Huntlee New Town, North Rothbury

Updated Traffic Impact Assessment (TIA) for Modification 21 (MOD21)

Date 16/06/2023
Revision B
To Huntlee team/ Transport for NSW (TfNSW)
From Arcadis Australia Pacific Pty Ltd (Arcadis)
Project Name Huntlee development, North Rothbury
Subject **Updated Traffic Impact Assessment (TIA) for Modification 21 (MOD 21)**

Figure 5-1 Package of upgrading works to support 2,525 dwellings and 4.3 ha GFA

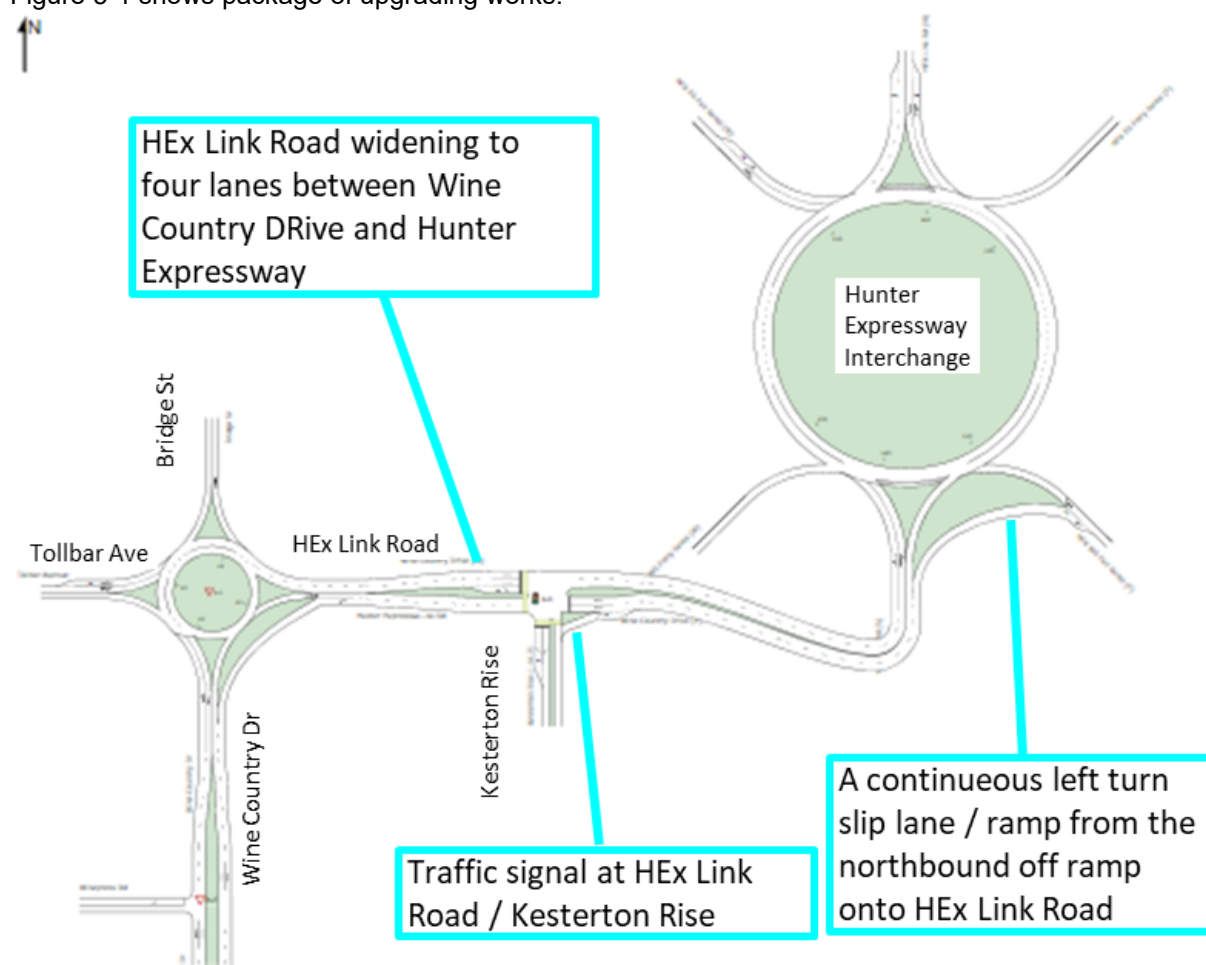
TfNSW comments	Huntlee Pty Ltd /Arcadis response
<p>4. Revised information is sought demonstrating that the proposed delays in critical infrastructure at intersections A-1 & A-11 can safely, and efficiency be accommodated. TfNSW would appreciate an understanding of whether additional upgrades are necessary to manage the development of the ultimate scenario safely and efficiently. Do some of the identified staged upgrades need to be brought forward to the subject application?</p>	<p>It is proposed to deliver the following three upgrade works in “one package un-staged” in relation to Condition E7(ix), (x) and (xi) prior to 2,525 dwellings and 4.3 ha GFA mixed use/commercial:</p> <ol style="list-style-type: none"> 1. New traffic signals at HEx Link Road / Kesterton Rise intersection 2. HEx Link Road widening to four lanes between Wine Country Drive and the Hex interchange 3. A new continuous left turn slip lane/ramp from the northbound off-ramp onto HEx Link Road <p>It is proposed to upgrade Wine Country Drive / Bridge Street / Tollbar Avenue roundabout to provide two lanes on the northern approach (Bridge Street) prior to 2,600 based on the MOD 21 amended DA plan.</p>

SIDRA traffic modelling was undertaken for the revised threshold of 2,525 dwellings and 4.3 ha GFA assuming the following three upgrades to be delivered as one package:

1. New traffic signals at HEx Link Road / Kesterton Rise intersection
2. HEx Link Road widening to four lanes between Wine Country Drive and the HEx interchange

3. A new continuous left turn slip lane/ramp from the northbound off-ramp onto HEx Link Road

SIDRA model shows that proposed upgrade (ie. new continuous left turn slip lane/ramp from the northbound off-ramp onto HEx Link Road) would provide level of service B or better at Hunter Expressway Branxton interchange.

In conclusion, the analysis supports the revised thresholds of 2,525 dwellings and 4.3 ha GFA for Consent 10.

Figure 2-1 Indicative layout for Wine Country Drive / Bridge Street / Tollbar Avenue roundabout upgrade

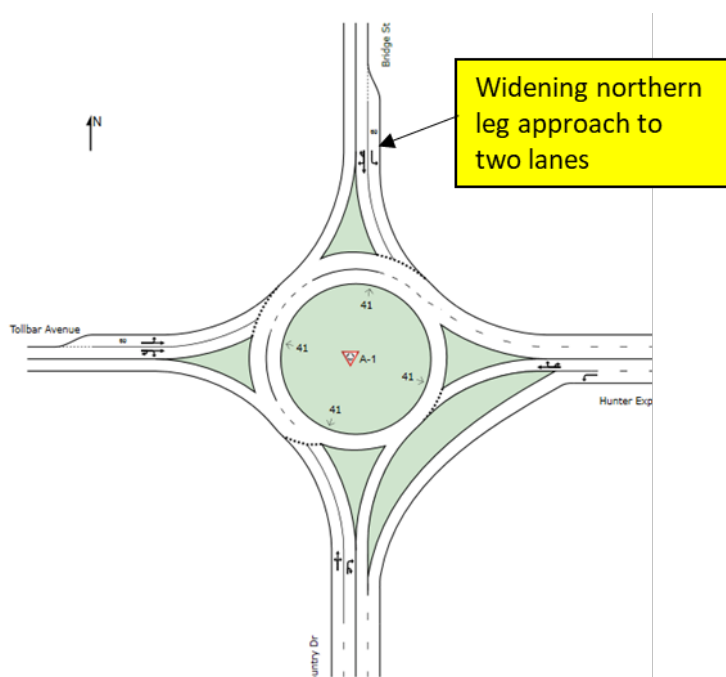
<p>3. The submitted TIA has undertaken an assessment of the subject development with respects to the operation of the existing road network, in particular intersections A-1, A-3 & A-5.</p>	<p>The MOD 21 proposal is an extension of the Huntlee Stage 1 development boundary. The MOD 21 proposal will result in the modified Stage 1 proposal consisting of 3,014 dwellings and 14.3 ha GFA.</p> <p>Additional traffic modelling has been undertaken to assess traffic impact of the modified Stage 1 proposal. The analysis shows that:</p> <ul style="list-style-type: none"> • Further upgrade would be required at Wine Country Drive / Bridge Street / Tollbar Avenue roundabout (A-1) to provide two lanes on the northern approach (Bridge Street). This additional upgrade at A-1 is proposed to be delivered prior to 2,600 lots being developed. • Wine Country Drive / Empire Street intersection (A-3) and Wine Country Drive / Triton Boulevard intersection (A-5) would provide adequate capacity to accommodate traffic generation from the modified Stage 1 proposal. <p>The supporting analysis for MOD 21 proposal is included in Attachment B.</p>

The above revised total Stage 1 development yield has been tested on the local road network as outlined in the following sections and it has been concluded that the MOD 21 proposal would trigger an additional upgrade at Wine Country Drive / Bridge Street / Tollbar Avenue roundabout. The upgrade includes:

- Widening northern leg approach to two lanes (Bridge St) (refer to Figure 2-1).
